**Mitigating Systems Performance Index Pilot  
Working Group Public Meeting  
December 3, 2003**

Appendix H

Presentation for  
ROP Public Meeting

Response to Comments Received on  
10/10/03

Figure 5.1: Road Map for LERF-based Risk Significance Evaluation for Type A Findings at Fullpower

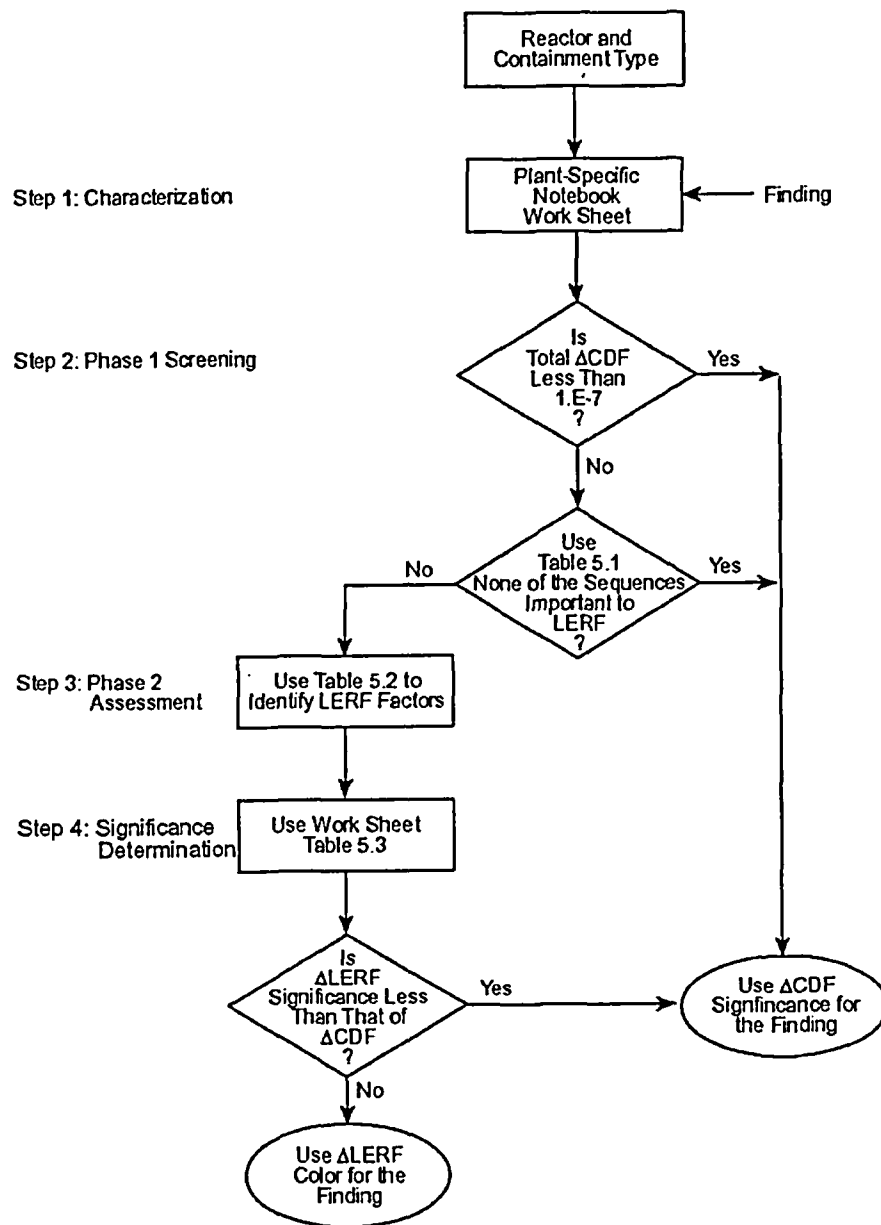
- ❑ “Logic diagrams (e.g. Figure 4.1 and 5.10 have diamond blocks with negative questions”**

2) Some of the logic diagrams(e.g. Figures 4.1 and 5.1) have diamond blocks with negative questions-This can be confusing.....

**Response:**      **Staff will adjust wording to make it clear.**

-Staff will consider changes in the forthcoming revision of the appendix.
